HISTORIC AND DESIGN REVIEW COMMISSION

November 04, 2015

HDRC CASE NO: 2015-432
ADDRESS: 415 CEDAR ST
LEGAL DESCRIPTION: NCB 2968 BLK 3 LOT 4
ZONING: RM4 H HS
CITY COUNCIL DIST.: 1
DISTRICT: King William Historic District
LANDMARK: House
APPLICANT: Jim Poteet/Poteet Architects, LP
OWNER: James & Kate Ball
TYPE OF WORK: Tax Certification, rehabilitation and addition
REQUEST:

SITE PLAN

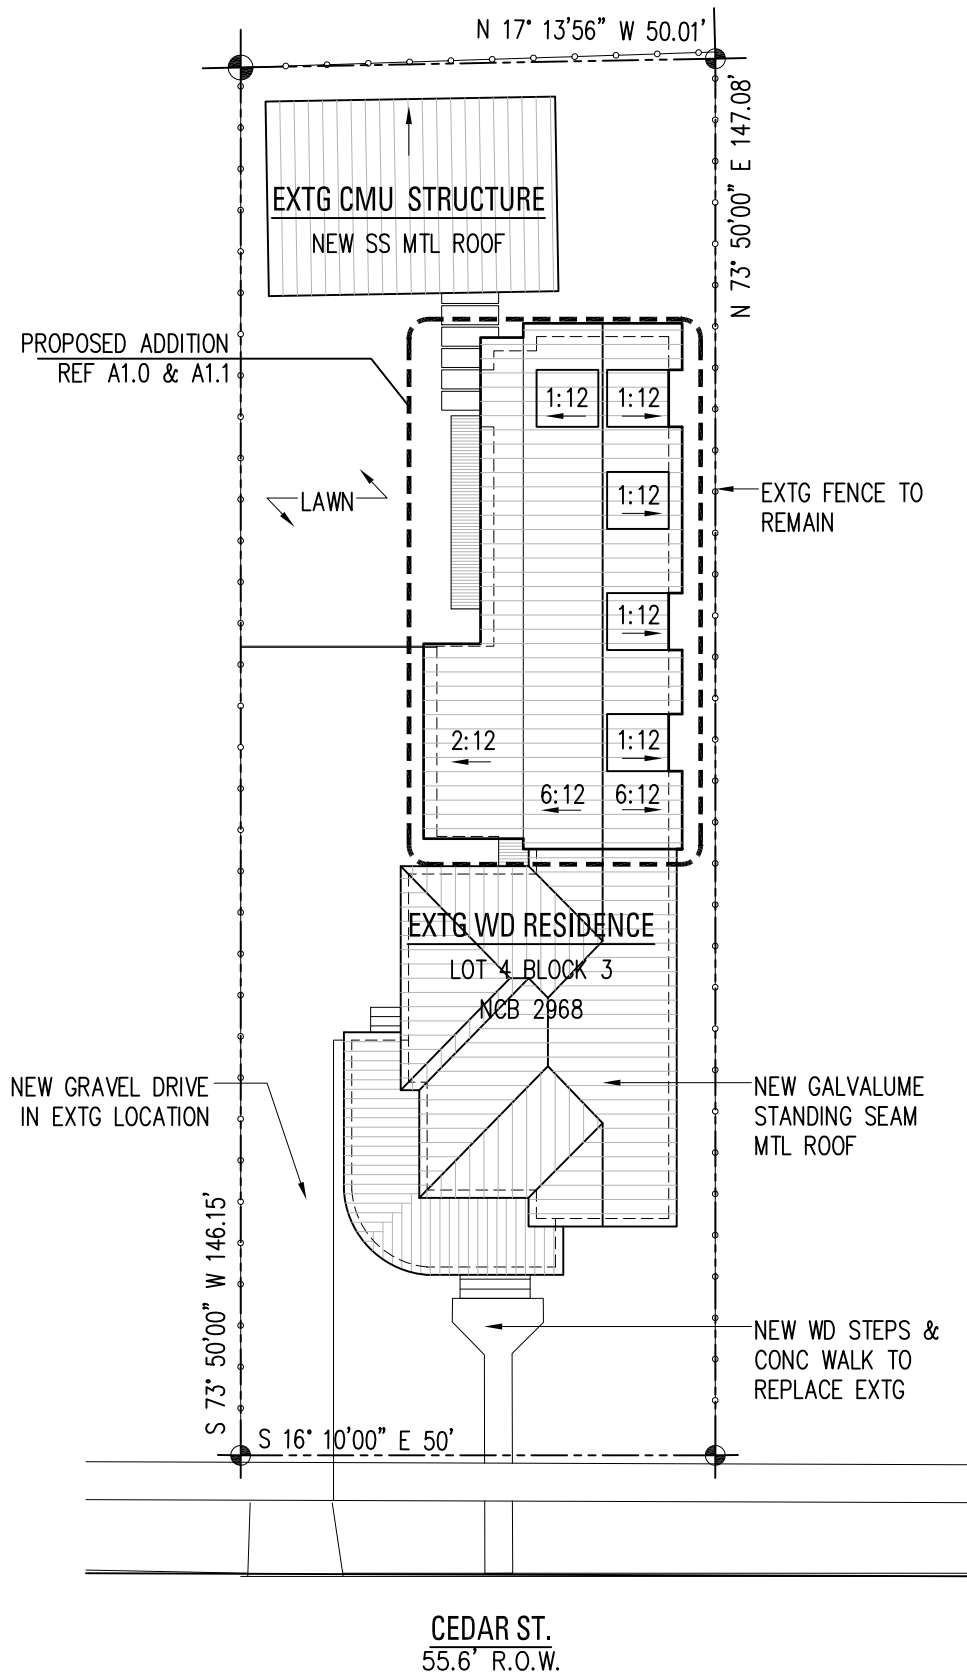
- j. While the applicant has not provided staff with specifics regarding the proposed square footage of the addition, the applicant has provided a site plan noting the added footprint to the site. While the added footprint is larger than typical for a rear addition, staff finds it appropriate given the amount of side yard that will remain lawn area.

EXTERIOR ELEVATION: EAST

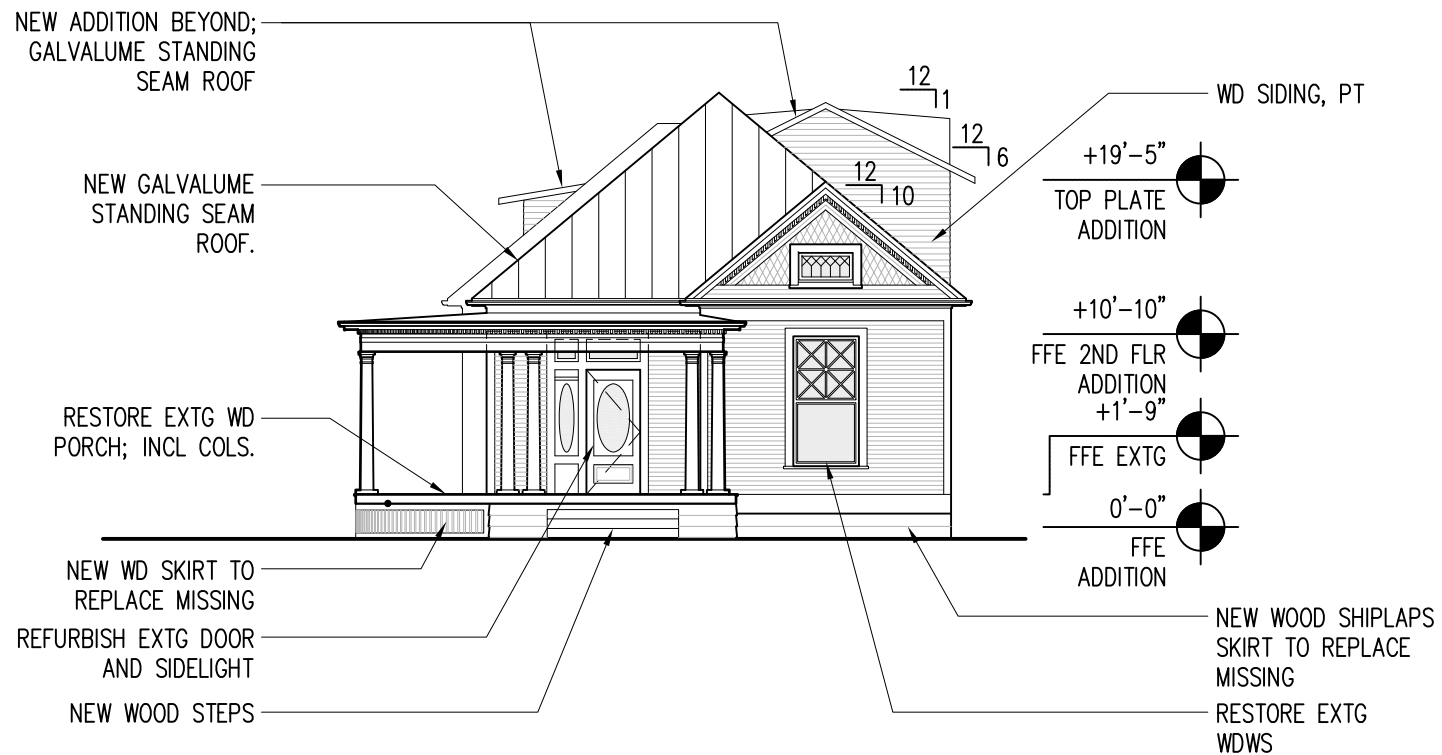
- i. Additions should be designed in a manner that their massing should be subordinate to that of the principle facades. The applicant has provided an elevation of the front elevation which displays the proposed addition being seen from the public right of way, above the roof line of the historic structure. This is not consistent with the Guidelines for Additions 1.B.i.

- k. Generally, the height of new additions should be consistent with the height of the existing structure. While the applicant has proposed for the addition's ridge line to be below that of the tallest ridge line of the primary structure, the majority of the addition will be taller than the primary historic structure. As noted in finding e, staff recommends the applicant provide additional perspectives to ensure that the proposed addition will not negatively impact the

- i. A line of sight study to ensure that the proposed addition will not impact the street facing façade of the primary historic structure as noted in finding e.

- ii. Additional perspectives to ensure that the proposed addition will not negatively impact the historic structure's appearance from the public right of way as noted in finding k.
